The Commission has issued the enclosed Amendment Nos. 6.7 and 6.8 to Facility Operating License Nos. DPR-42 and DPR-60 for the Prairie Island Nuclear Generating Plant, Unit Nos. 1 and 2 in partial response to your application dated June 24, 1983.

PRAIRIE ISLAND NUCLEAR GENERATING PLANT UNIT NO. 1

AMENDMENT NOS. 67 AND 61 TO FACILITY OPERATING LICENSE

SAFETY EVALUATION BY THE OFFICE OF NUCLEAR REACTOR REGULATION

FIGURE TS.3.10-7

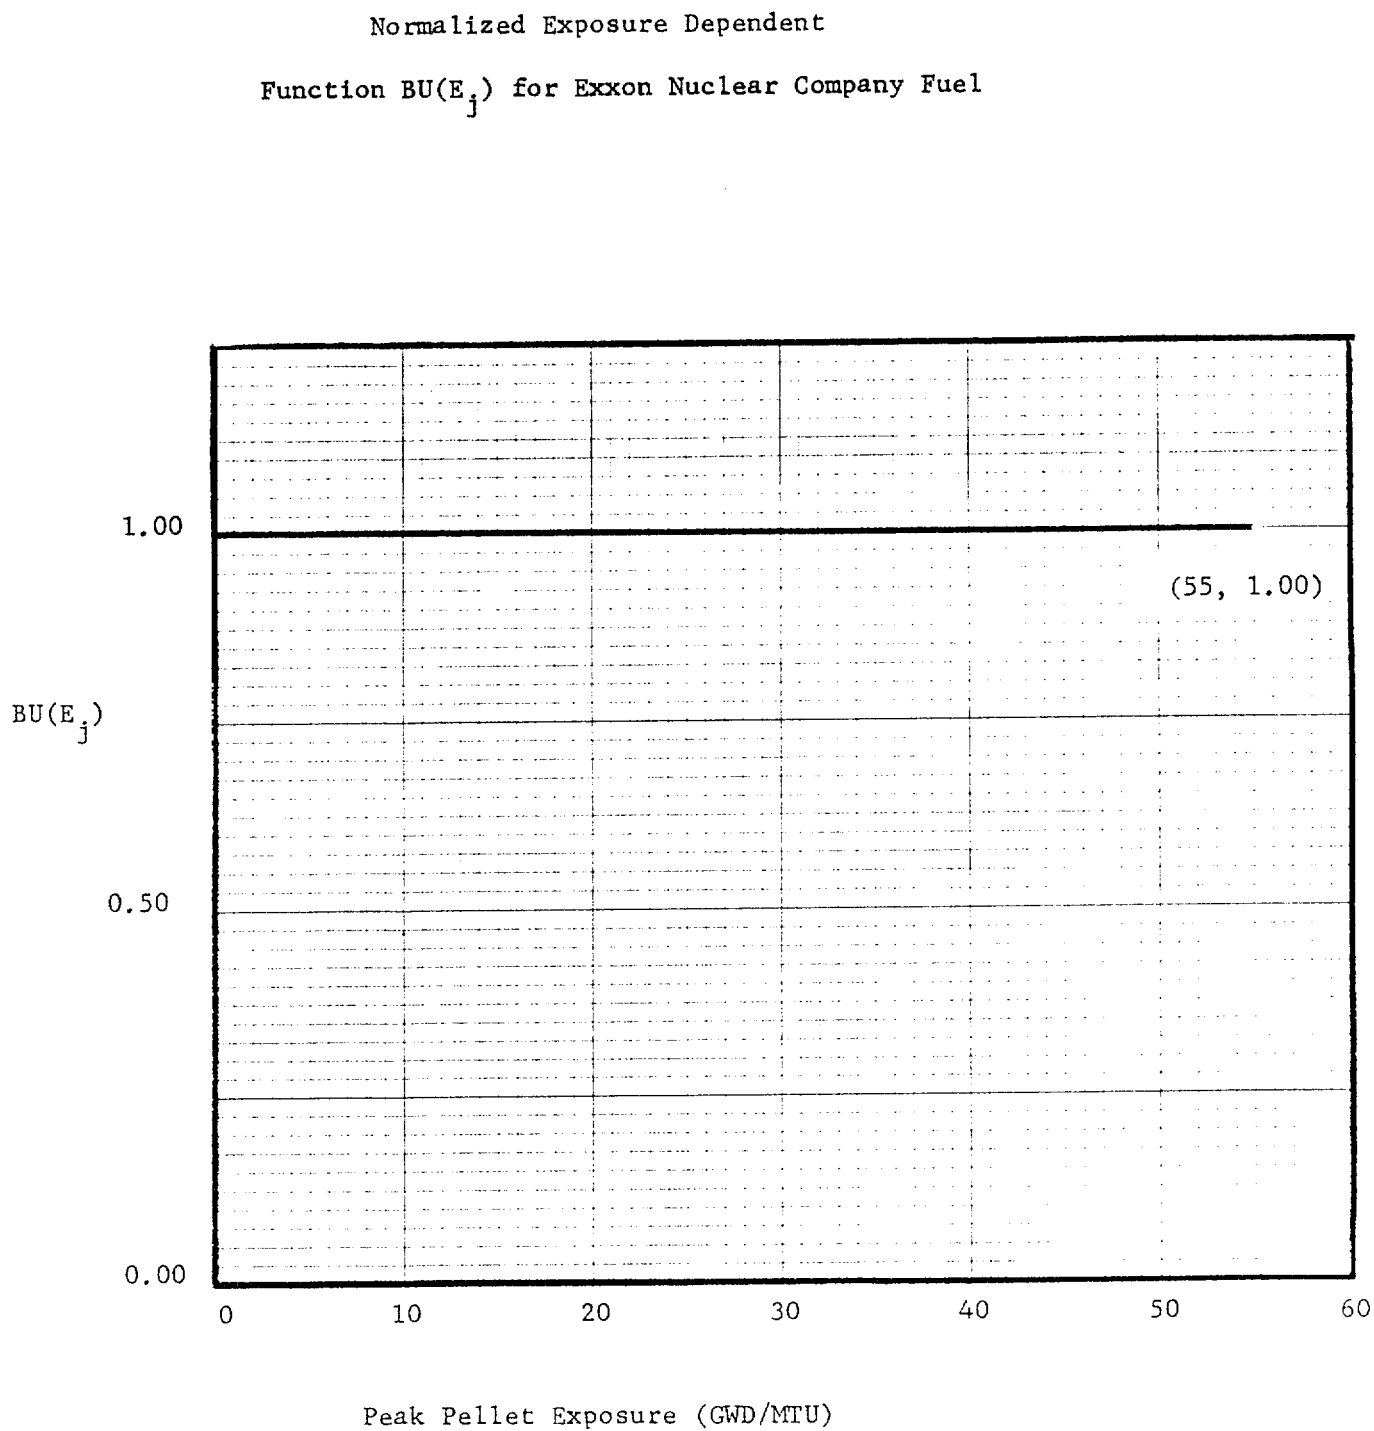
The amendments change the exposure dependence function $Bu(z)$ to 1.0 for all values of peak pellet exposure from 0 to 55 GWD/MTU. These amendments complete all items that you requested by letter dated June 24, 1983.

By letter dated June 24, 1983 Northern States Power Company (NSP) requested changes to the Technical Specifications (TS) for the Prairie Island Nuclear Generating Plant Units Nos. 1 and 2. The proposed TS changes involve the local power hot channel factor F_0 limit in the TS 3.10-1, 3.10-2, 3.10-9 and 3.10-11 where (1) a numerical value in the F_0 limit expression will be changed from 2.21 to 2.32; and (2) the normalized exposure dependence function $Bu(z)$ curve will be changed to 1.0 for all values of peak pellet exposure from 0 to 55 GWD/MTU in Figure TS.3.10-7. The Commission, by letter dated October 3, 1983 issued Amendment Nos. 66 and 60 related to the local power hot channel factor F_0 limit and this evaluation addresses the normalized exposure dependence function $Bu(z)$ curve appearing in the Figure TS.3.10-7.

The LOCA analysis was performed with two analyses: from the beginning of life to 15 GWD/MTU and from 15 GWD/MTU to 55 GWD/MTU. The most limiting fuel conditions in the respective exposure ranges were used in the analysis. The combination of the highest stored energy, rod pressure and decay power was used to bound the LOCA-ECCS analysis over the exposure ranges. The results of these analysis have shown the maximum peak cladding temperatures to be 2091°F and 2142°F, respectively, for the fuel exposure ranges prior to 15 GWD/MTU and up to an exposure of 55 GWD/MTU. The local metal-water reactions are 4.68% and 5.6% for the two fuel exposure ranges, and total core metal-water reaction is less than 1%. These peak clad temperatures (PCTs) and metal-water reactions are within the limit imposed in 10 CFR 50.46, "Acceptance criteria for emergency core cooling systems for light water nuclear power reactors". Therefore the proposed change of the exposure dependence function $Bu(z)$ is acceptable as this function relates to the LOCA analysis.
